**BLANDAIR REGIONAL PARK - PHASE 1 BUILDING CONTRACT**

Project: Blandair Park - Phase 1

# PARTIAL SITE PLAN - COMFORT STATION - UNDERGROUND CONDUIT PLAN - ESK-01 - JULY 20, 2012

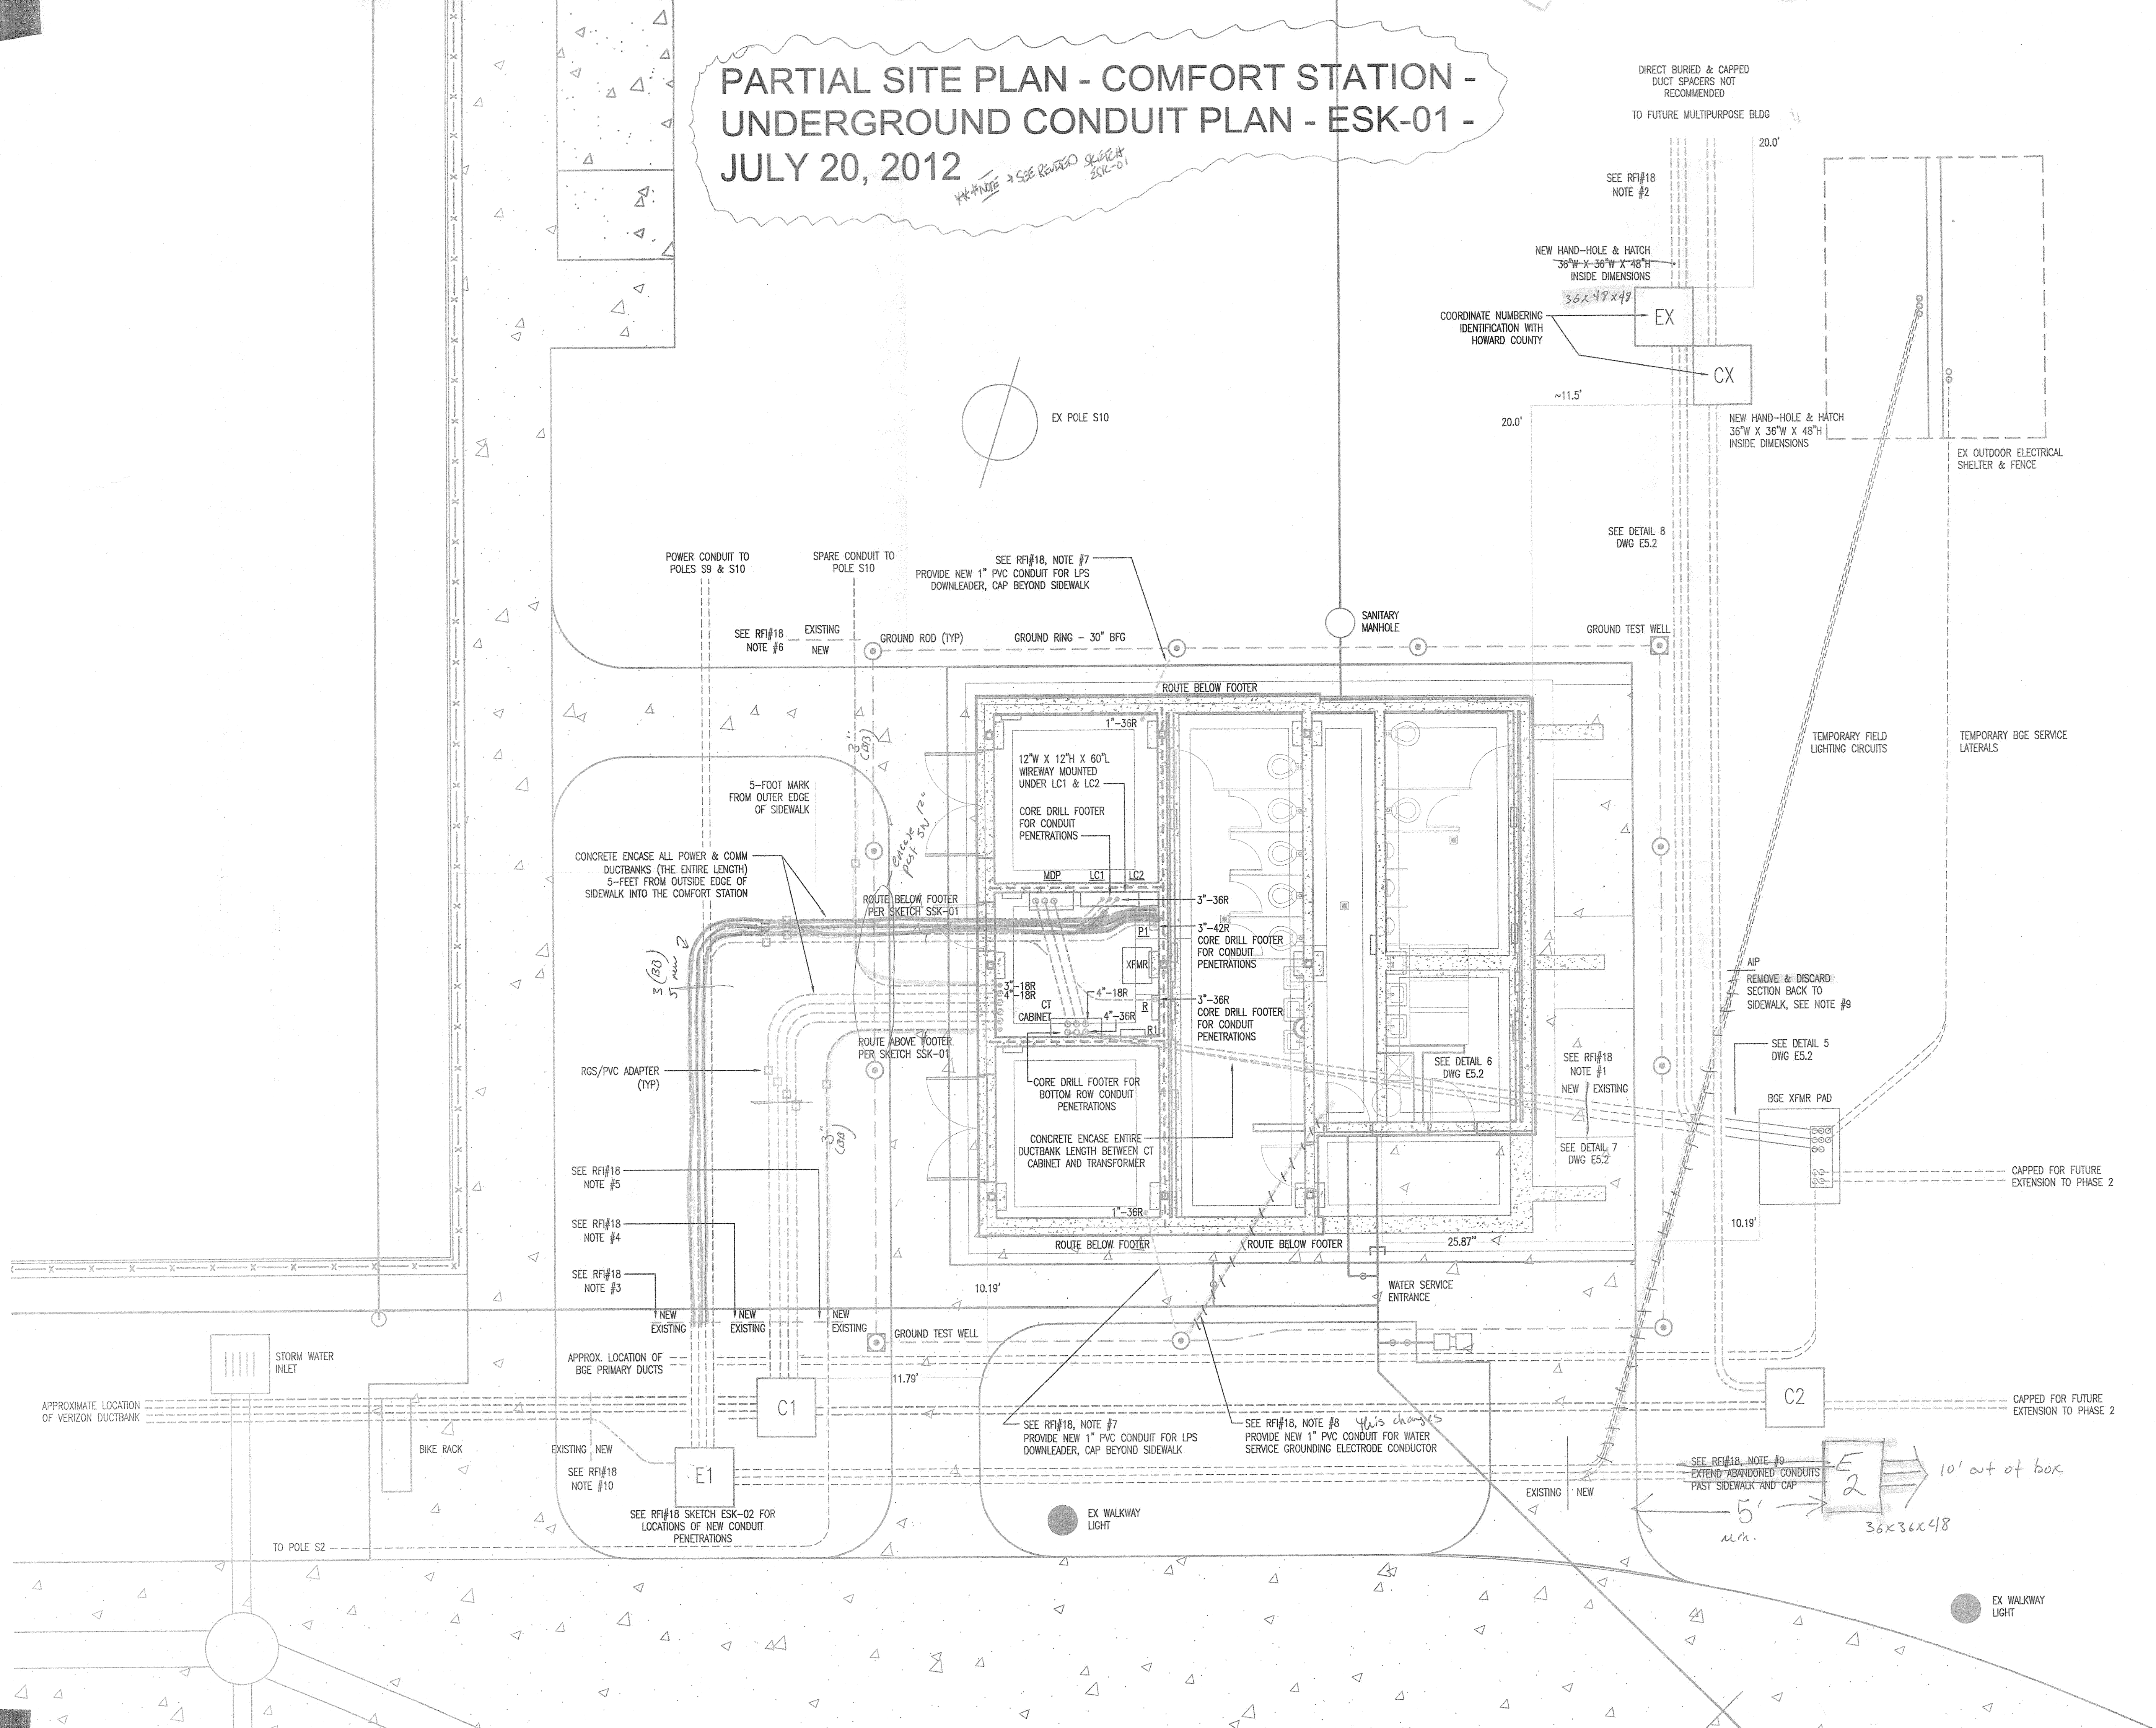
*Handwritten note: SEE REVISION SKETCH ESK-01*
